Z O N I N G  
A D J U S T M E N T S  
B O A R D  
S T A F F R E P O R T

FOR BOARD ACTION  
MARCH 13, 2025

## 2655 Shattuck Avenue

Use Permit #ZP2024-0057 to demolish a one-story, 8,185-square-foot, non-residential building and construct an eight-story (85 feet), 84,399-square-foot mixed-use residential building containing 97 dwelling units (including ten Very Low-Income Density Bonus qualifying units) and 2,117 square feet of commercial space on a 23,527 square foot lot.

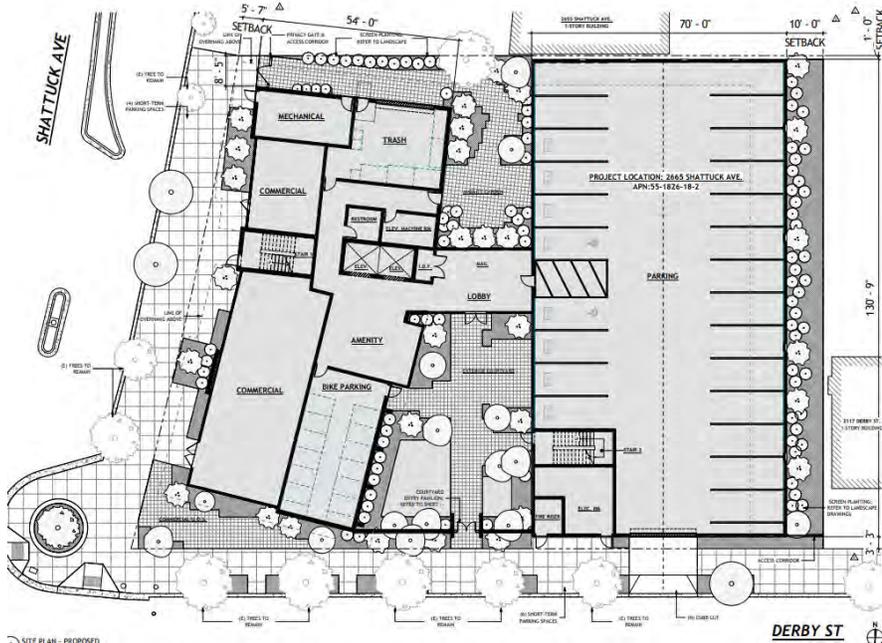
The garage door situated across from Walker Street- as detailed by my letter thrusts all the negatives noise, exhaust, congestion, interface with pedestrians and bicycles deep into our residential neighborhood. The garage entrance should be on the Shattuck side where there is already a cut out.

**Regarding the location of the garage – The applicant did look into relocating the entrance to Shattuck Avenue but determined that it was not the best use of space on the site. Also, Shattuck Avenue is the busier roadway, for vehicular traffic and pedestrians, so reducing driveways on Shattuck is important to create a better pedestrian environment.**

**The project is located in the Adeline Corridor Specific Plan which has design strategies for parking and activation of primary street frontages. Strategies include locating parking and vehicle areas behind, within, or under buildings; limiting parking on the primary street frontage, minimizing the visual impact of parking and parking garage entrances on primary street frontages; providing active uses on ground floors on primary frontages; ensuring that ground floor uses and facade design in the Adeline Area positively contribute to the pedestrian experience and street character. So, locating the parking entrance on Derby is consistent with the Specific Plan.**
